TRANSISTORS, LOW POWER, NPN, BASED ON TYPE 2N2222A

ESCC Detail Specification No. 5201/002

DOCUMENTATION CHANGE NOTICE

FIGURE 2(b) - VARIANTS 04-05-09-10

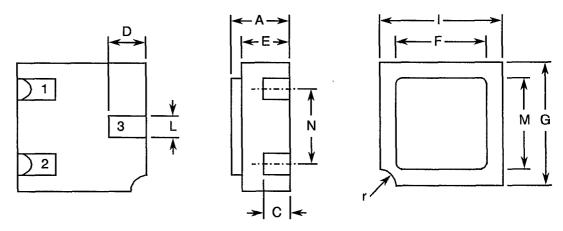
1	1	: Imperial Dimensions deleted from Table and Notes	221356
	1		: Notes and Note references renumbered	221356
	l	Figure 2(b)	: New Figure added	221356
1	1	Figure 3	: Note amended	221356
1	}	Para. 4.2.3	: Deviation text amended	221356
	1	Para. 4.3.2	: Text amended	221356
1	1	Para. 4.3.3	: Second sentence amended	221356
1			: Applied Force deleted	221332
1	I	Para. 4.4.1	: Existing text deleted and new text added	221356
l		Para. 4.4.2	: Existing text amended and new text added	221356
1		Para. 4.5.1	: Existing text deleted and new text added	221356
1		Para. 4.5.5	: Deleted in toto	221356
I		Para. 4.7.2	: New paragraph added	221356
			: Existing paragraph renumbered to "4.7.3" and second sentence amended	221356
l		Para. 4.7.3	: Renumbered as "4.7.5" and text amended	221356
		Para. 4.7.4	: New paragraph added	221356
1		Table 5(a)	: Entry added	221356
	1			
1
